PROJECT
BROKEN HILL POLICE STATION
80 Blende Street, Broken Hill NSW 2880

DRAWING TITLE
Development Proposal
Elevations - Sheet 1 of 2

PROJECT No	DRAWING No	REVISION
20001	DA0004	A
DRAWING SCALE	SHEET SIZE	DRAWN
1 : 100	B1	<i>[Signature]</i>
ARCHITECT	CHECKED	DATE

SOUTH EAST ELEVATION

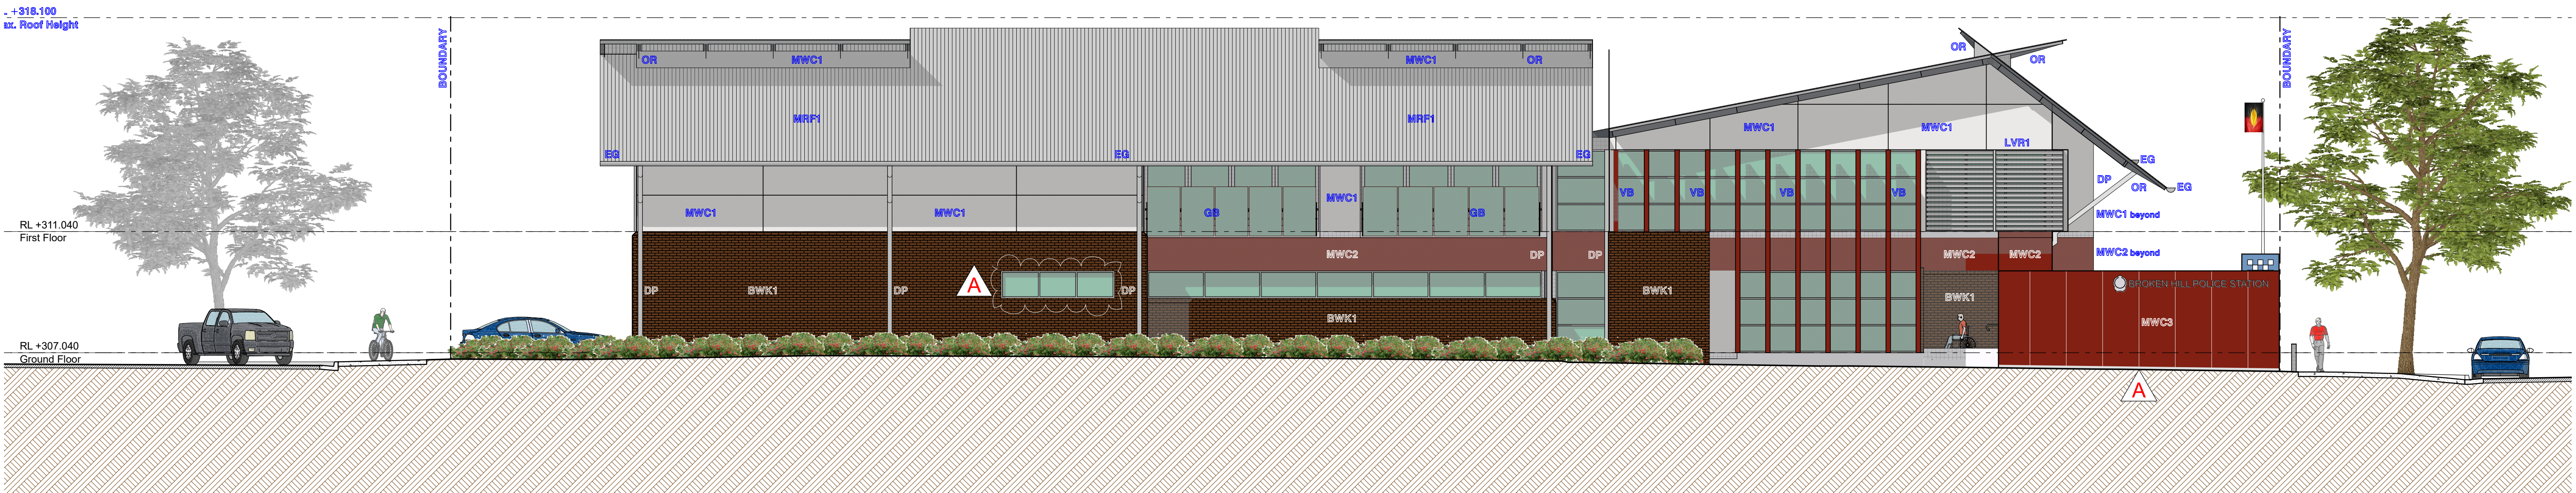
A	Signage Feature Wall revised (not clouded for clarity) SE Elevation - Entry Wall revised to include Indigenous Artwork SW Elevation - Window added Legend - Nomenclature added & revised	18/11/2020
REVISION	DESCRIPTION	DATE
